San Francisquito Creek HEC-RAS Model Third-Party Peer Review February 2024 (SFCJ.01.23)

SAN FRANCISQUITO CREEK
JOINT POWERS AUTHORITY

Schaaf & Wheeler
4699 Old Ironsides Drive, Suite 350
Santa Clara, CA 95054

Figure 3-3: Initial Spatially Varied Roughness Assignment (Middlefield Road to University Avenue)

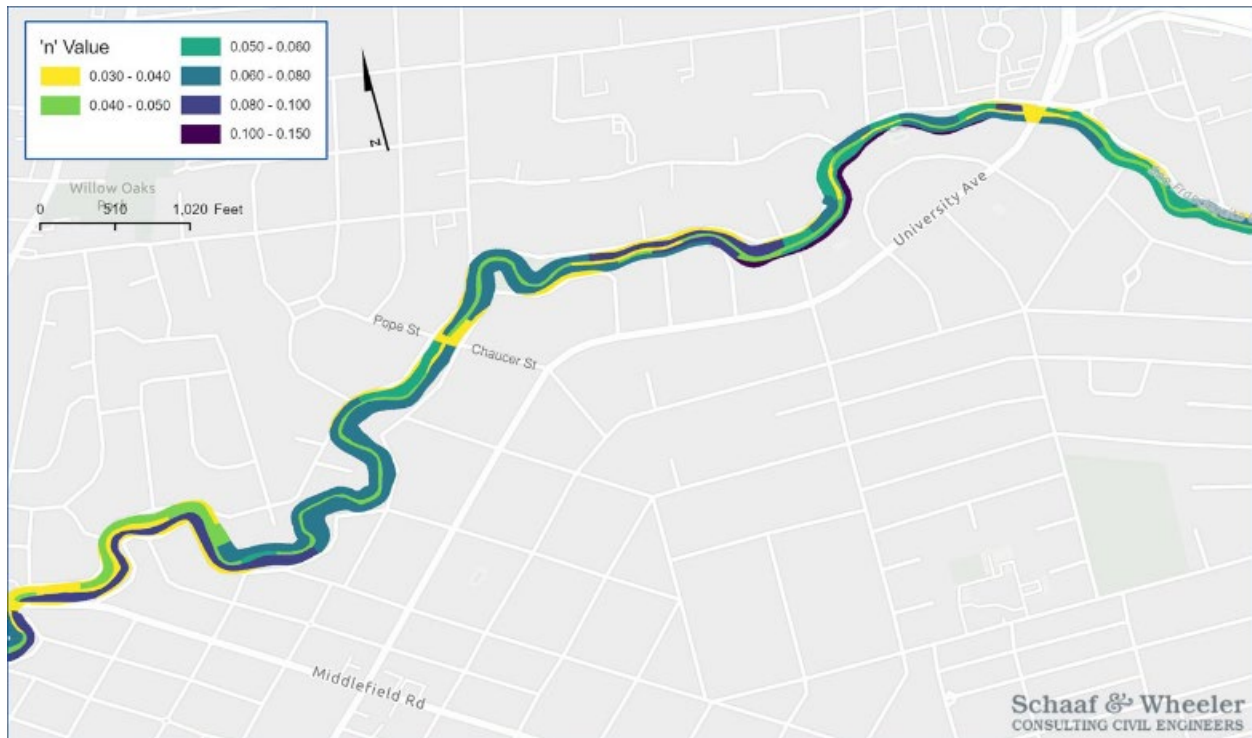
Based on photos and aerial imagery, Schaaf and Wheeler developed land cover polygons representing variable roughness in the main channel, side slopes, and overbanks. Initial estimates of roughness were assigned, and the polygons overlain on the model’s land cover mapping as shown by Figure 3-3. In addition to vegetation cover, channel roughness, represented as n-value or Manning coefficient, can be considered a lump parameter representing the effects of bed forms, sediment transport, superelevation at bends and other three-dimensional flow behavior to reproduce that flow behavior averaged in a single dimension.

Figure 3-4: Revised Cross Section Roughness (top) Compared to Existing Model (bottom)

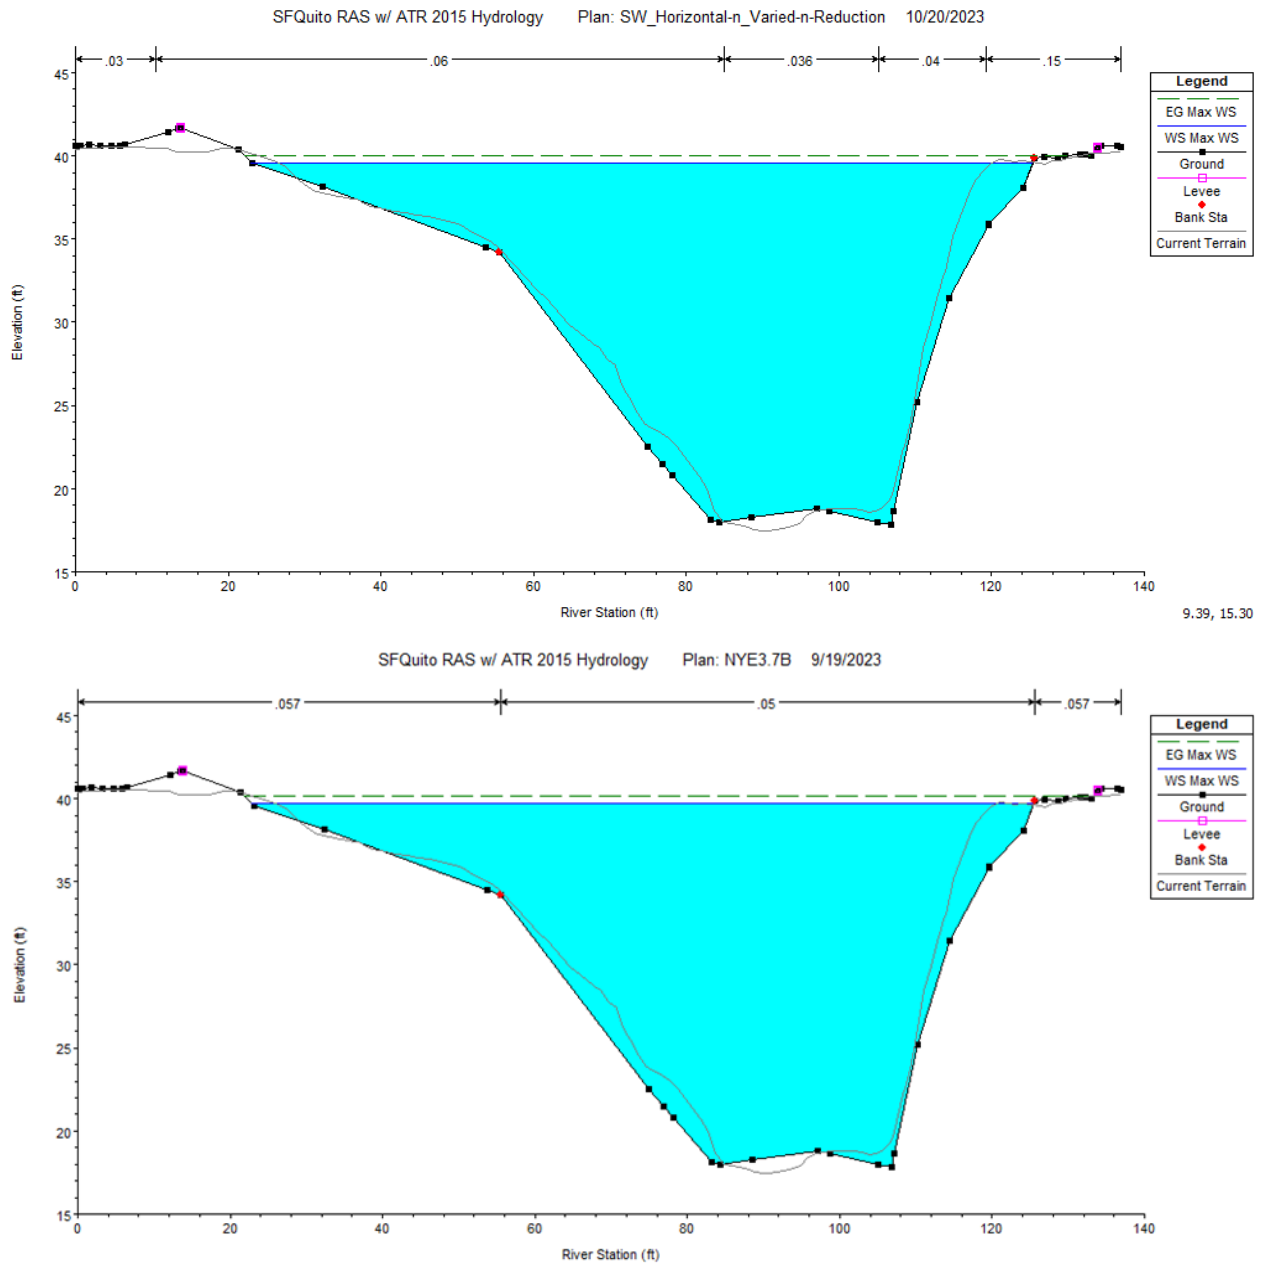
For the cross section shown, the revised main channel roughness is lower than in the existing model. However, the lower value only applies effectively to the channel bottom, where flow depths are greater and resistance from vegetation is less likely to impact flow velocity. The left bank side slope roughness within the red channel bank markers is represented by a comparatively higher value while the right bank side slope is less than the existing model main channel roughness, meaning there is less resistance to flow along the Palo Alto bank at this location and flow is moving faster than previously assumed.

At this section, which is just upstream of the private pedestrian bridge between Pope/Chaucer and University Avenue, the composite roughness for the main channel (between the bank markers) is 0.048 in the revised model, which is close to the composite roughness found in the existing Valley Water model. However, there is more variability in composite section roughness within each reach represented in the revised model. Given the dynamic nature of the NYE22 flood event, this variability has proven necessary to replicate the observed creek spills.

Figure 3-5: Revised Spatially Varied Roughness Assignment from Caltrain to Middlefield Road

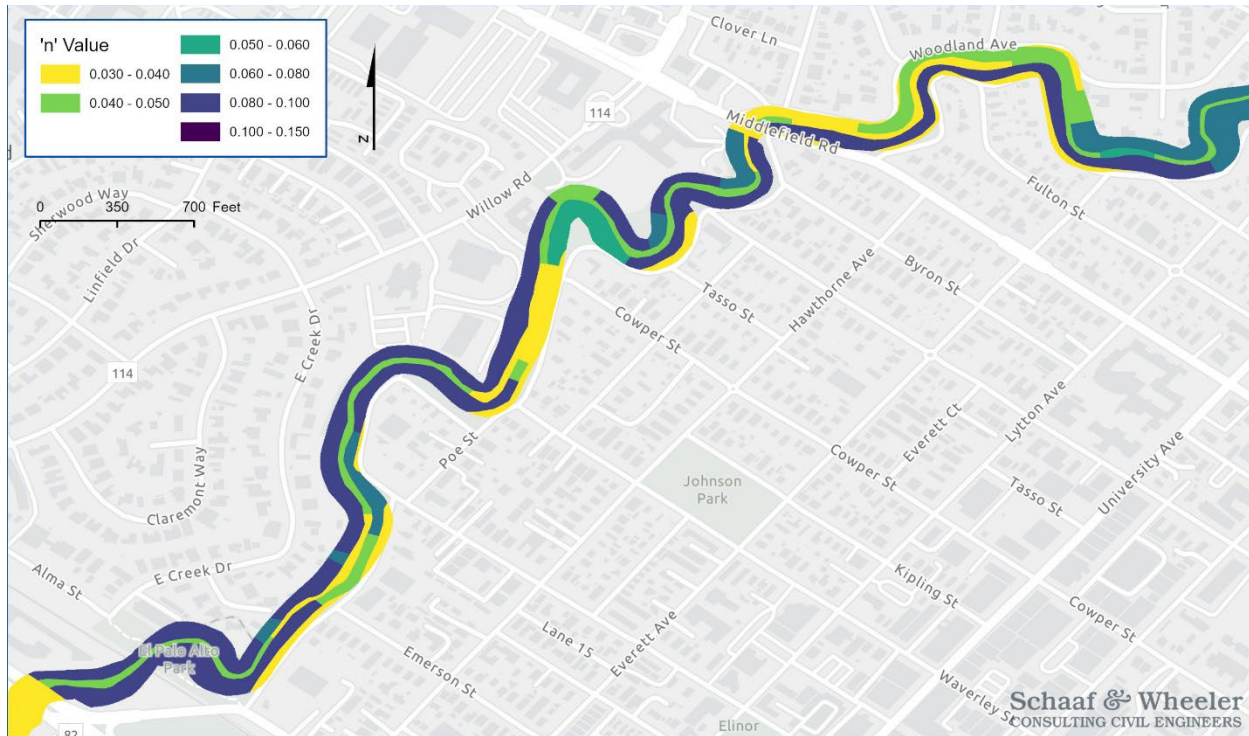
The best way to compare the results of this process is to examine the existing model main channel n-values (which already represent a composite n-value between the top of bank points) against the composite main channel value from the revised model (calculated by HEC-RAS at the maximum depth). Table 3-1 provides a comparison of n-values in various reaches that connect to the 2D areas. Within each of these reaches, the Valley Water model’s main channel roughness is uniformly assigned for all cross sections. Model parameters upstream of CalTrain and downstream of Highway 101 were not altered with this effort, because flows were not observed to have left the channel banks in those locations during the NYE22 event and there is no evidentiary basis for adjustment. Rather, the focus was on creek areas where the roughness likely had the greatest effect on hydraulic grade and overflow rate and volume from the Creek to the 2D surfaces, based on observed flow behavior during the New Year’s Eve event. Table 3-1 also summarizes revised model composite channel n-values, which are graphically shown for the reach of greatest numerical adjustment, between Caltrain and Middlefield Road, by Figure 3-5.

Other than the creek reaches from Caltrain to Middlefield, average composite n-values in the revised model are close to the existing model main channel n-values. However, the range of n-values in each reach includes some values that are significantly higher than the existing model. These localized high roughness areas can have a substantial impact on hydraulic grades. Higher values tend to reduce the flow velocity and raise the water levels in the creek. Even if that impact is limited to a short reach of the creek, localized high roughness values can make the difference between full containment and spill over the banks to the 2D surface. Localized high roughness segments of the creek throughout the evaluated reach also tend to be where the greatest debris racking might be expected, which cumulatively results in an even higher hydraulic grade line or Water Surface Profile (WSP).

Figure 3-6: Sample 2D Channel Flow Model at Creek Bends with Streamflow Lines

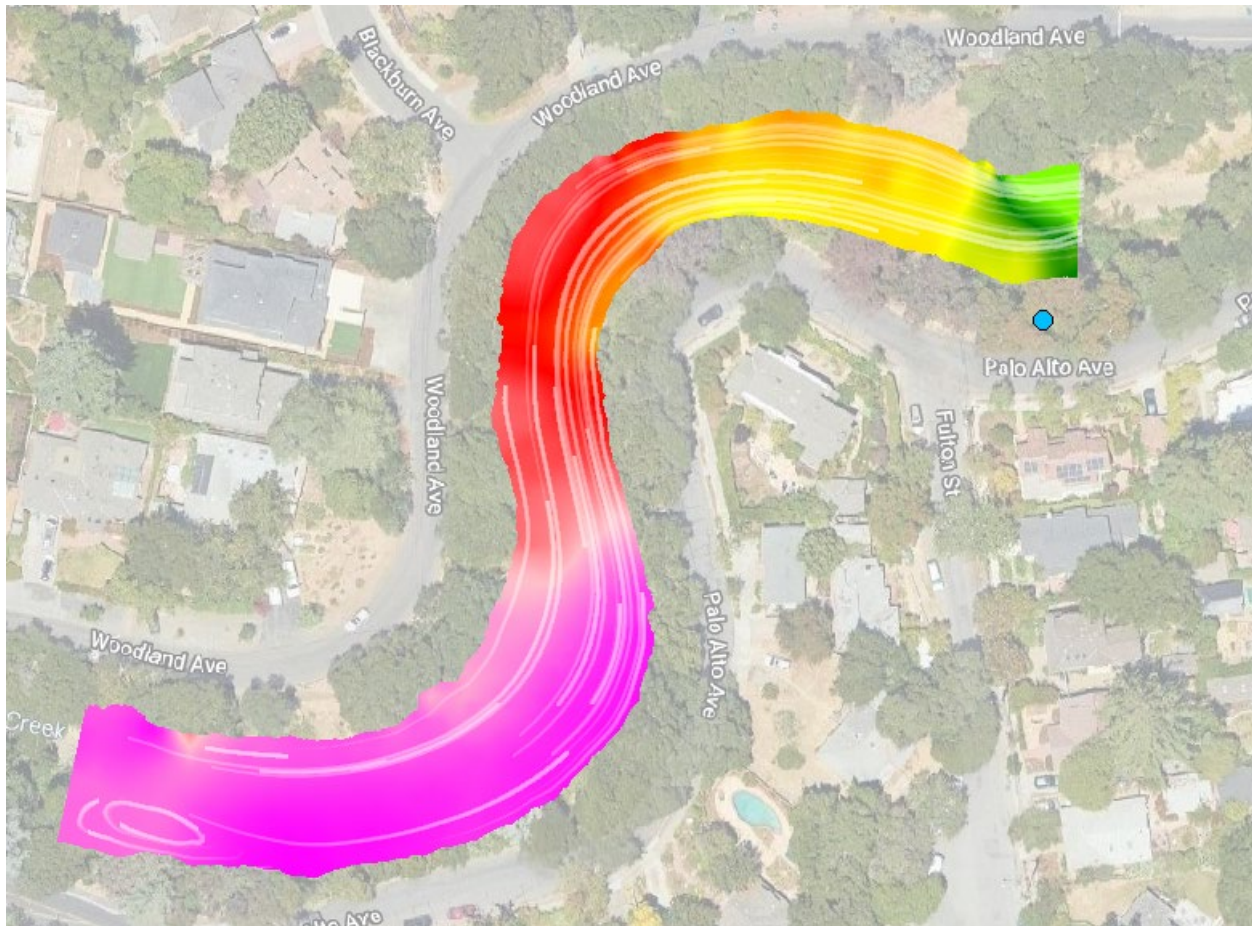
There are dozens of significant bends within the creek’s alignment. The 1D methodology used by HEC-RAS calculate water surface elevations does not directly address the hydraulic impact of the sinuous alignment or superelevation, which can be significant. The traditional mechanism in a one-dimensional model is to increase channel roughness (n-values) to replicate the observed behavior. Those adjustments are reflected in n-values previously described, graphed, and tabulated. Figure 3-6 shows the results of a separate two-dimensional in-channel model prepared to directly address superelevation, which is about one foot at outside bends.

Superelevation is typically added to the average water surface elevation calculated by HEC-RAS, so this means the foot of additional water depth caused by superelevation around an outside bend that is observed must be accounted for in the channel roughness adjustment.

Figure 3-7: Lateral Structure Adjacent to Woodland Ave at Emma Lane (Existing Model)

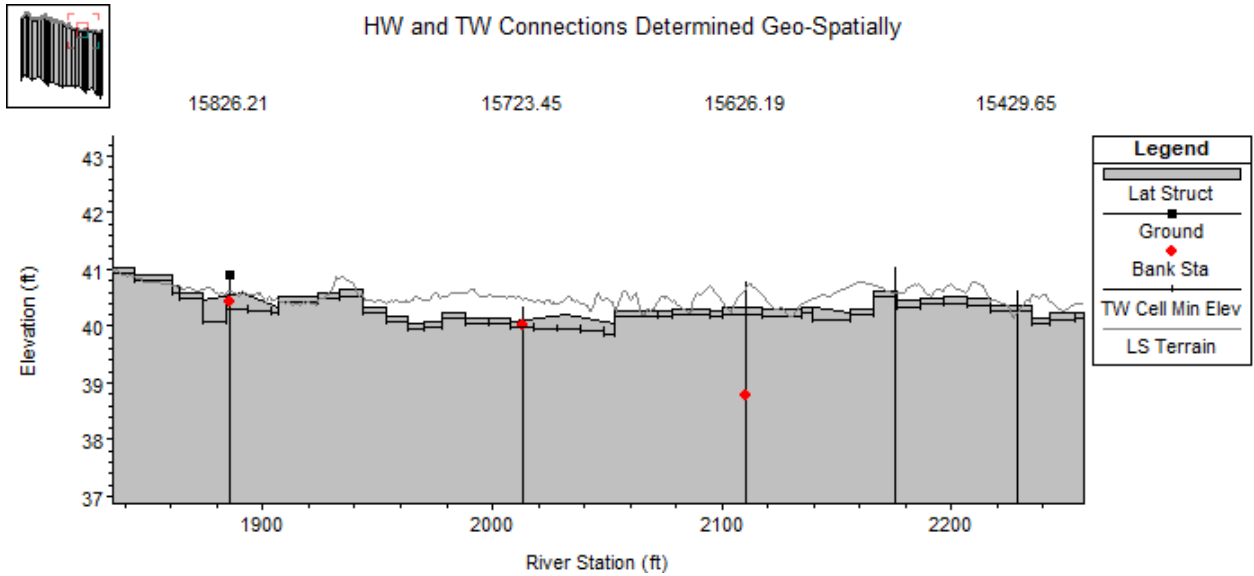
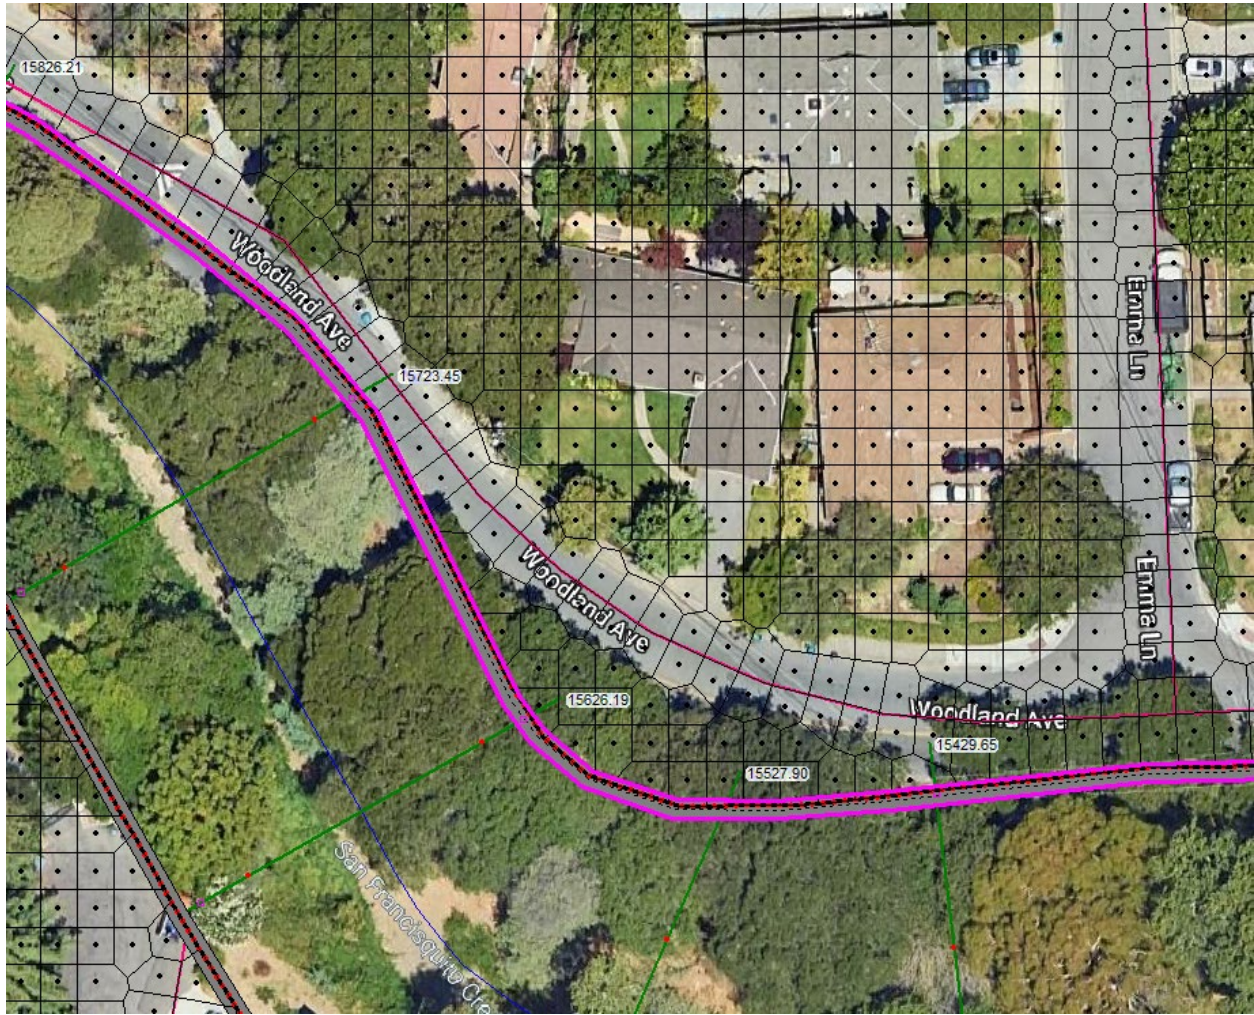
One lateral structure in the existing model where elevations appear to be set based on the 2D area cell faces is shown in Figure 3-7. At this location, the lateral structure alignment extends to the middle of the roadway. One identified issue with the existing model is that the lateral structure elevations are lower than the levee points defined by the cross sections. Modeled levee points do not prevent flow from spilling over the lateral structure, and this discrepancy results in an over-estimation of spill at certain points, particularly on the north (left bank) side of the creek.

Lateral structure alignments have been adjusted horizontally to better match the likely location of high points in the terrain, which contain creek flow until spilling would first occur. These structures are geo-referenced, and the model is capable of extracting elevations from the LiDAR terrain. Most surveyed cross sections indicate that the LiDAR is a reliable source of ground elevation data at the top of the creek banks, compared to within-channel elevations as previously discussed. Figure 3-8 provides an excellent example of this.

Figure 3-8: 2D Results and XS 14530.33 from the Existing Model

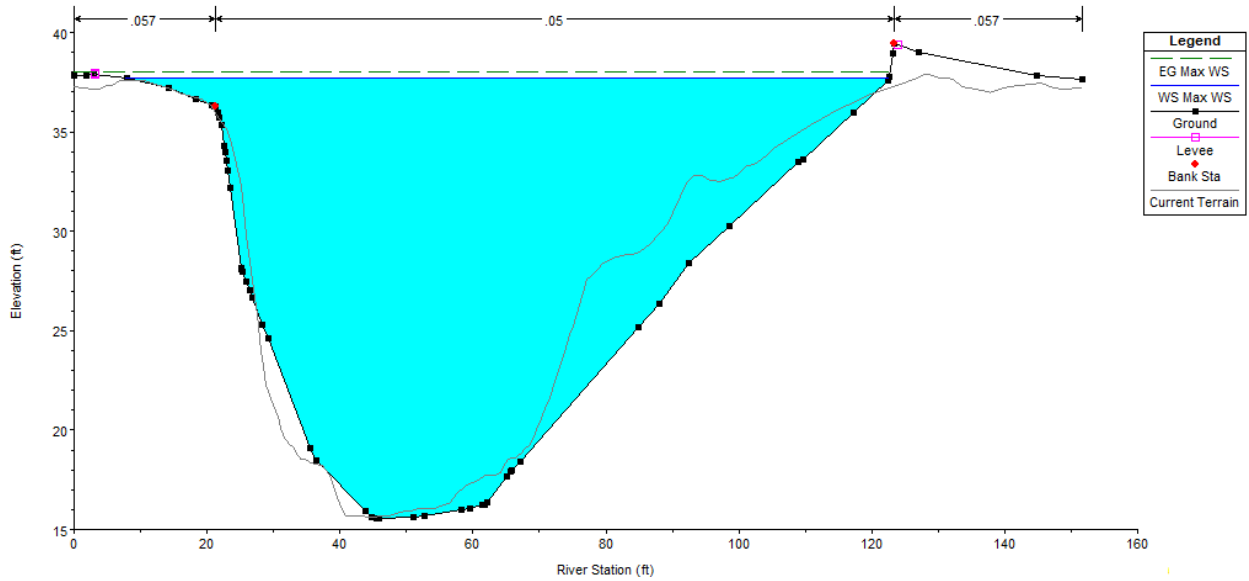
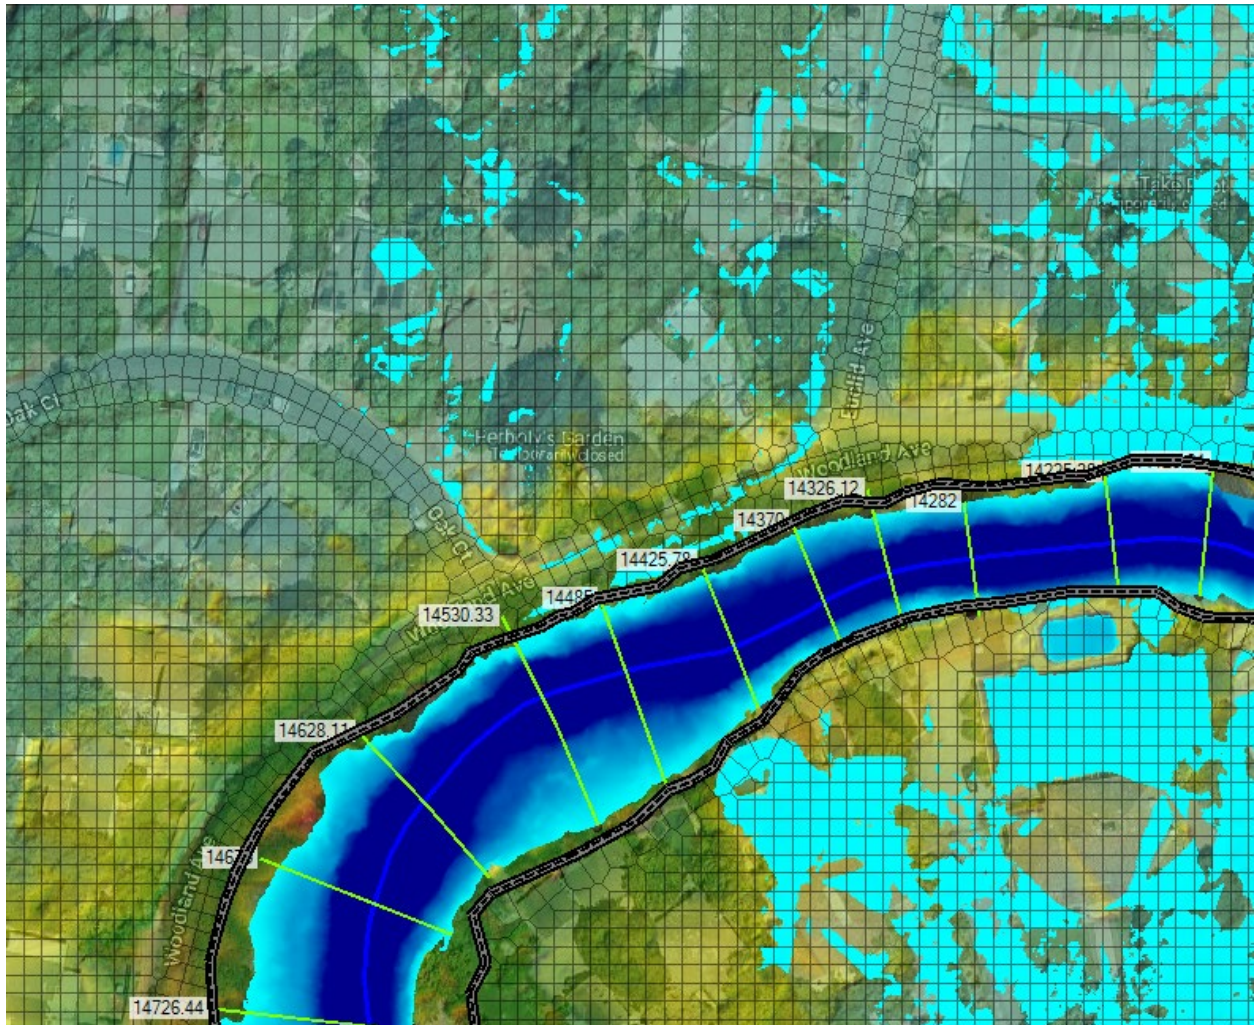
There are locations in the model where levee points are above lateral structure elevations. Cross section 14530.33 provides an example of this where the existing model is likely overpredicting spill volume. Figure 3-8 shows the 2D result, which makes it clear that spill is occurring from section 14530.33. However, the cross-section plot indicates that the water surface elevation does not exceed the defined left bank levee point at this location.

Figure 3-9 provides the maximum depth result in the vicinity of the same section after the lateral structure is realigned to better match the high point along the left bank and elevations are updated.
